- .1 Cover Page – Addendum No.6 – 1 page;
 - .2 Civil Addendum C2 dated March 28, 2018 – 1 page;
 - .3 Architectural Addendum A4 dated March 28, 2018 – 20 pages including 9 drawings;

Architectural Addendum A4

PROJECT TITLE	East Hants Aquatic Centre
---------------	---------------------------

PROJECT NUMBER

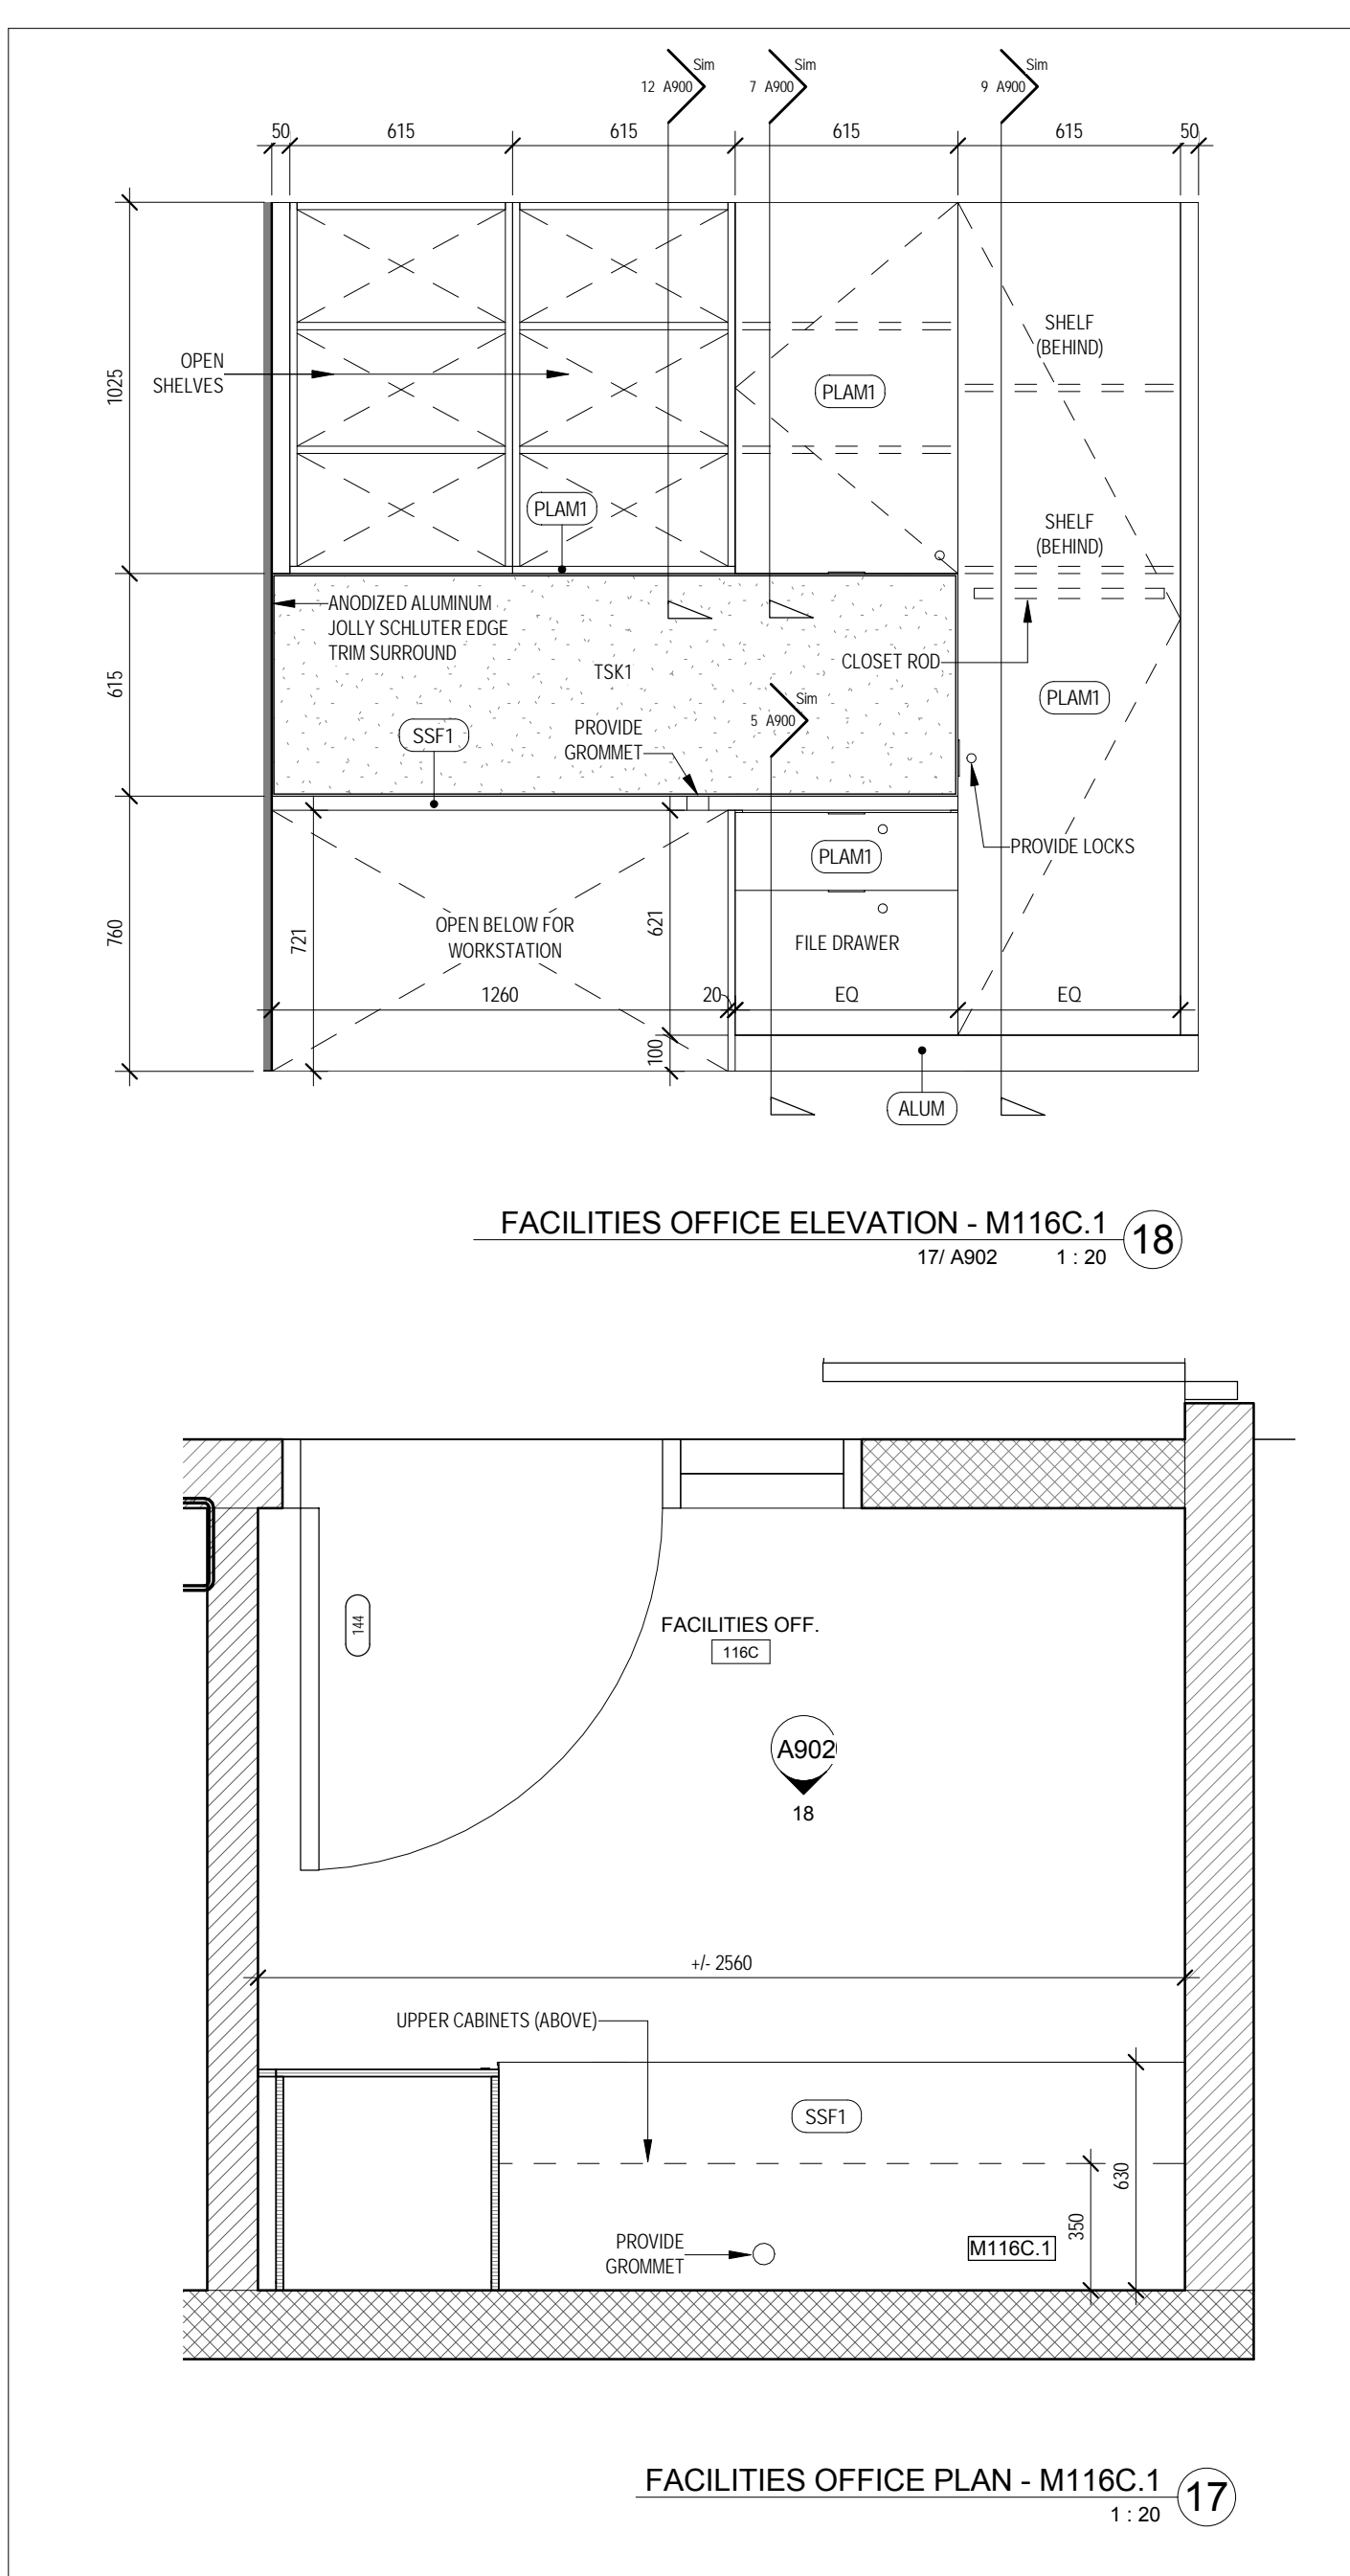
- .1 Drawing A900 “MILLWORK DRAWINGS”, dated 2018-03-28 “Issued for Addendum No.6 to replace and supersede drawing A900 “MILLWORK DRAWINGS”, dated 2018-03-01 “Issued for Tender”. Changes include but are not limited to:
 - .1 Detail 11/A900: REVISED to provide additional information regarding composition of cabinet door.

- .1 Drawing A901 “MILLWORK DRAWINGS”, dated 2018-03-28 “Issued for Addendum No.6 to replace and supersede drawing A901 “MILLWORK DRAWINGS”, dated 2018-03-01 “Issued for Tender”. Changes include but are not limited to:
 - .1 Detail 12/A901: REVISED to accommodate communications box, phone BIX and TV panels.
 - .2 Detail 13/A901: REVISED to accommodate communications box, phone BIX and TV panels.

MECHANICAL SCHEMATICS

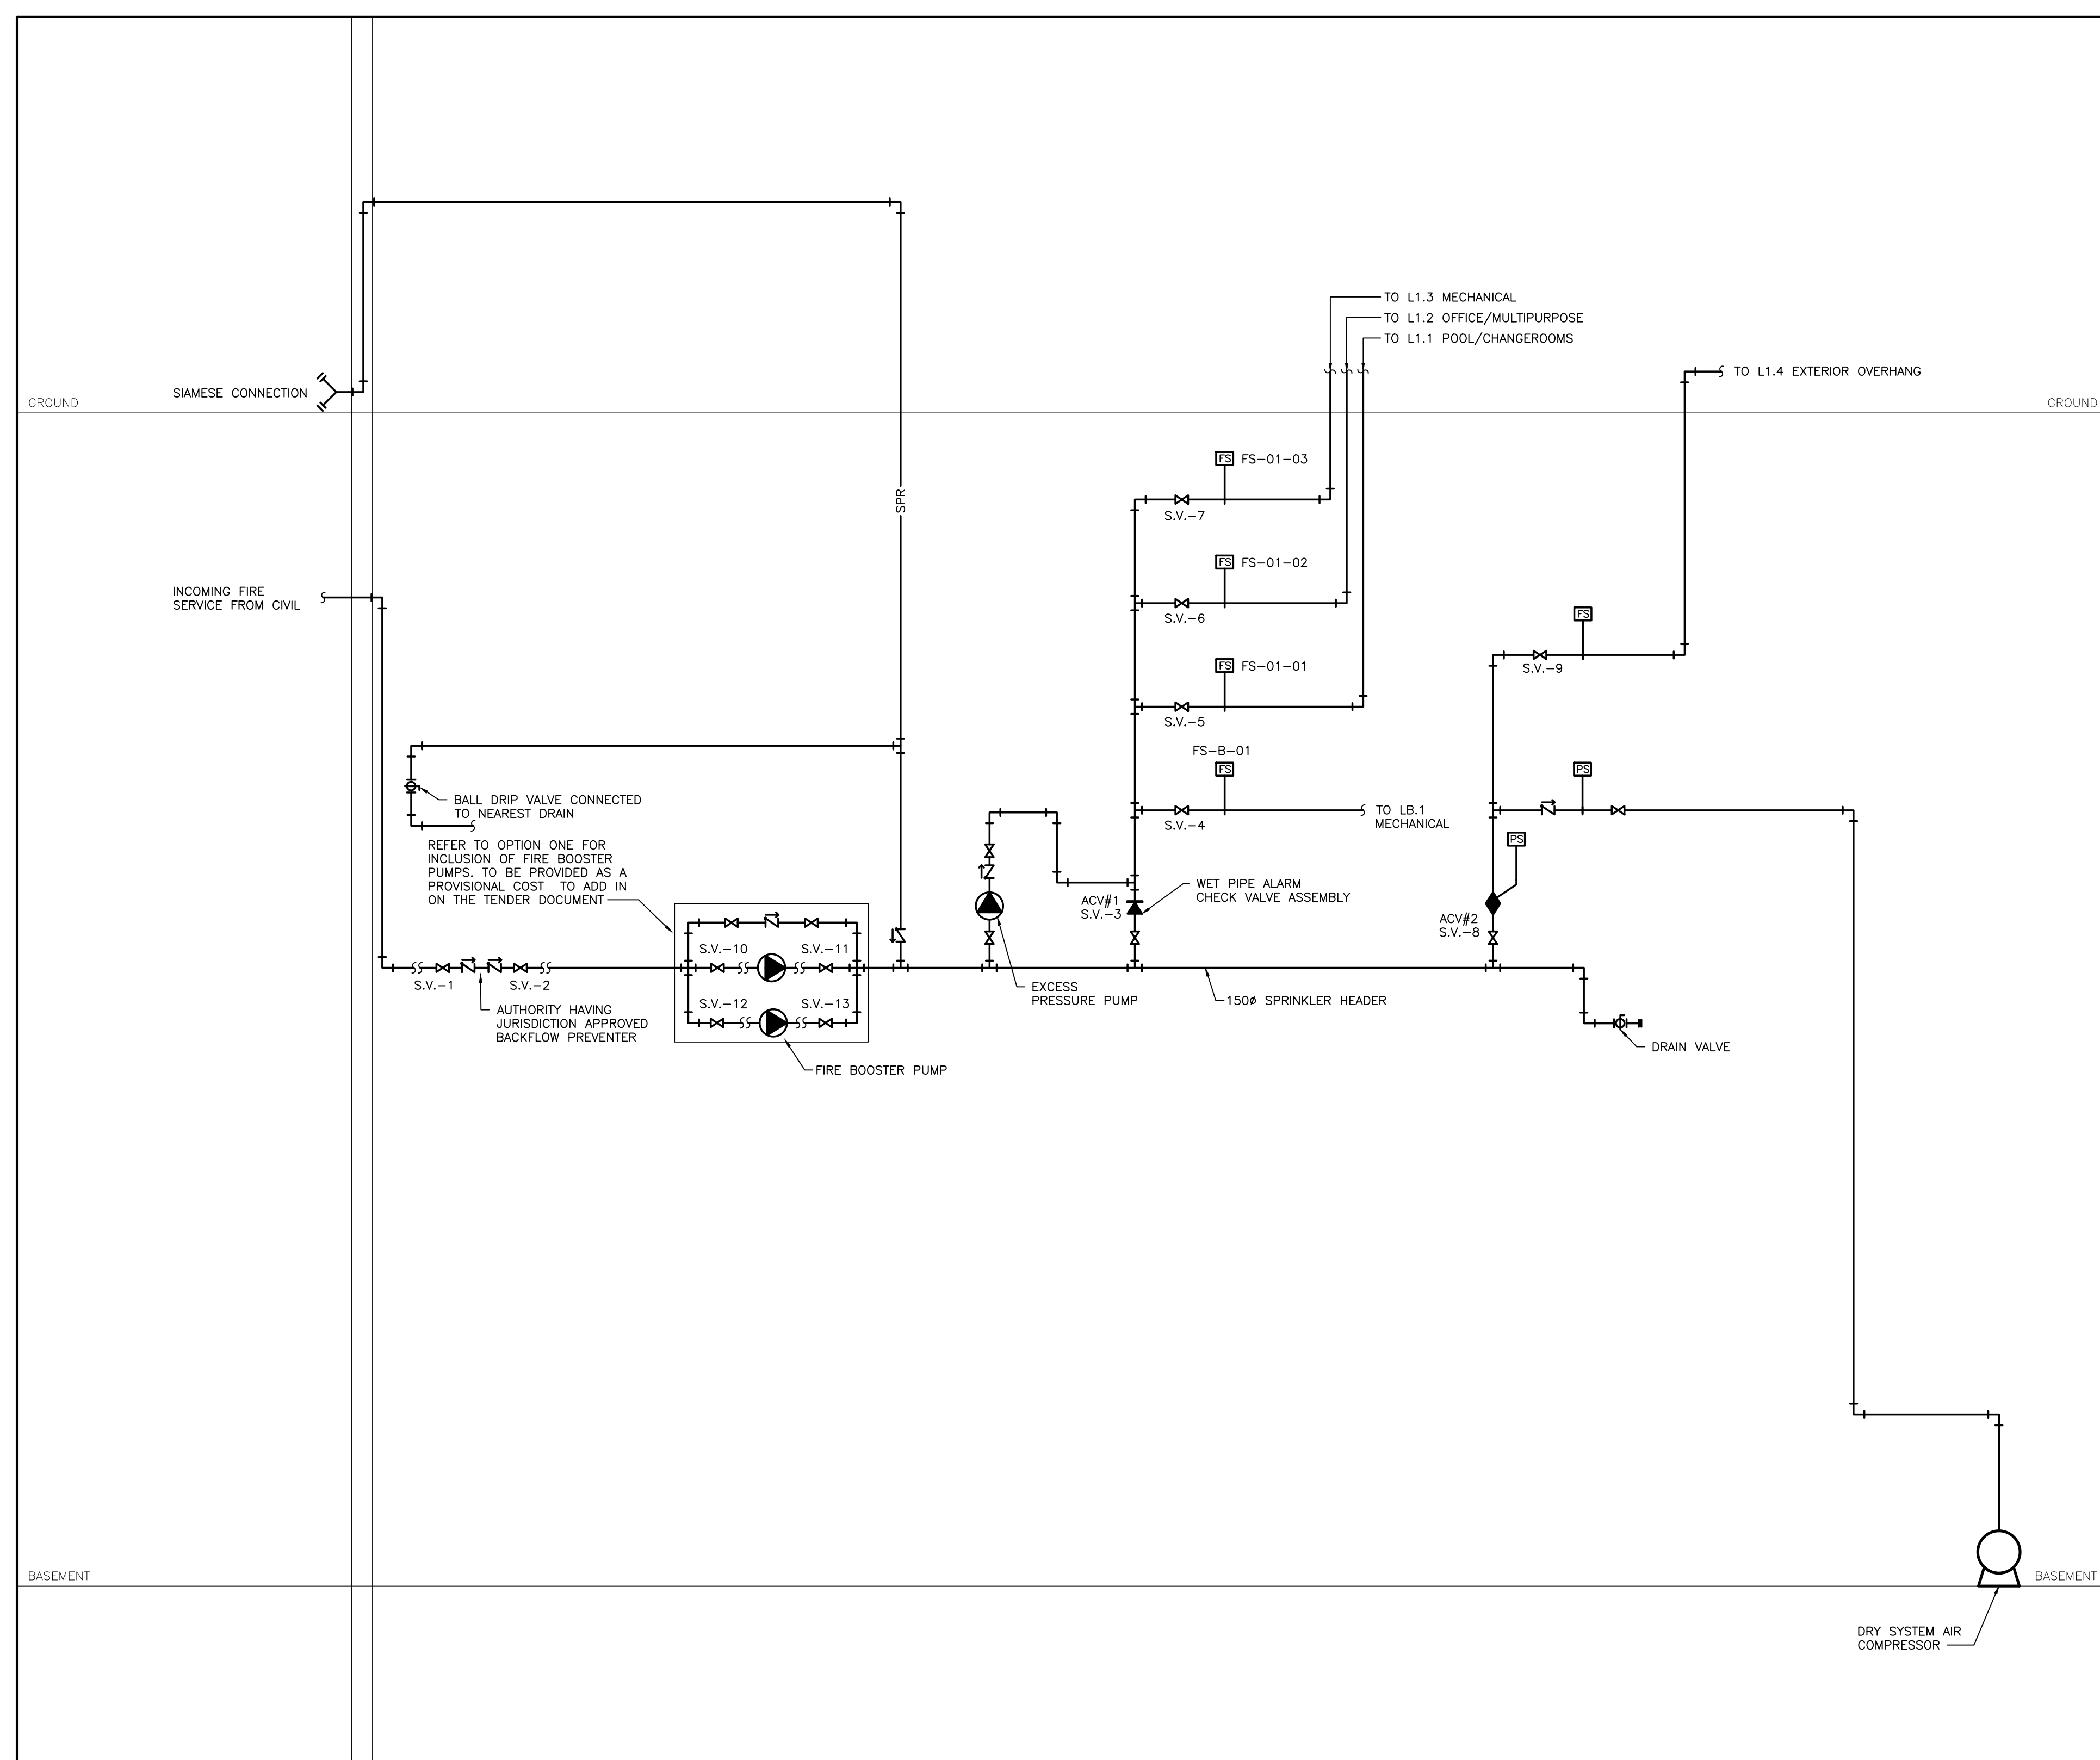
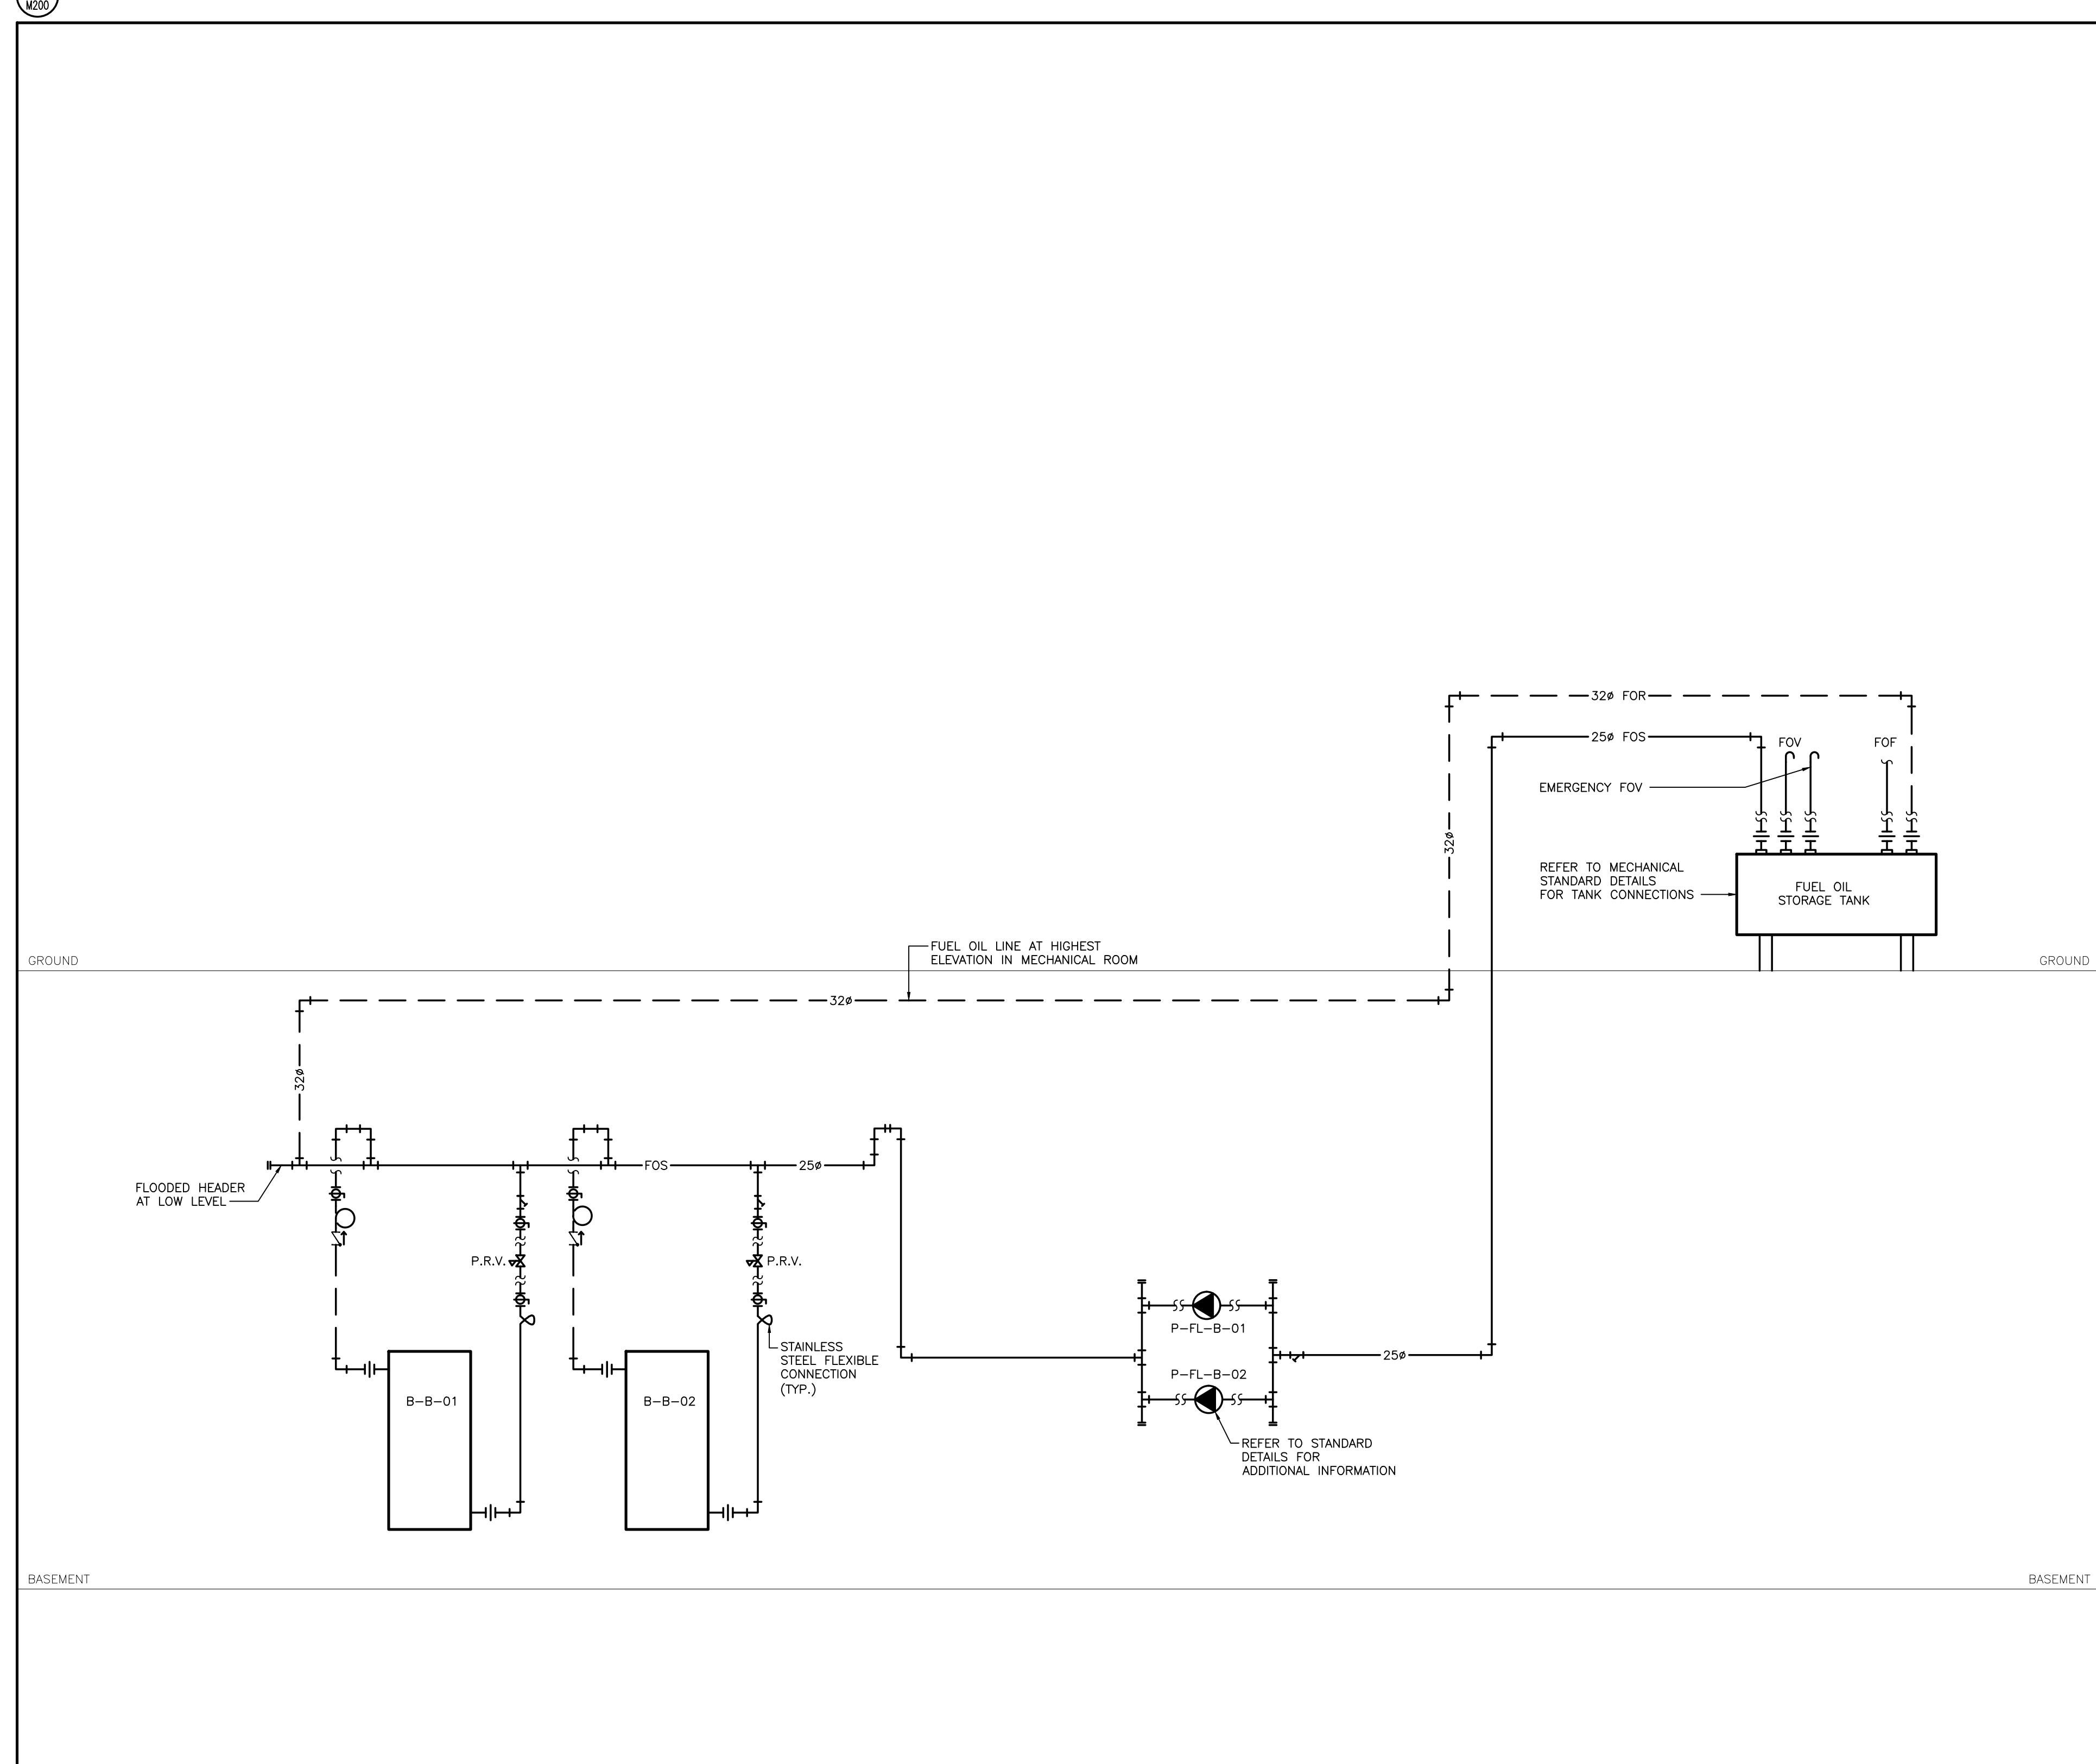
"Regarding drawing M600A on the lower left corner, the drawings indicate the exhaust pipe to be 3" in diameter. The exhaust pipe has a run of approximate 57ft and then up another 20ft. According to the engine manufacture 3"" will not be large enough. Please confirm pipe size diameter. "
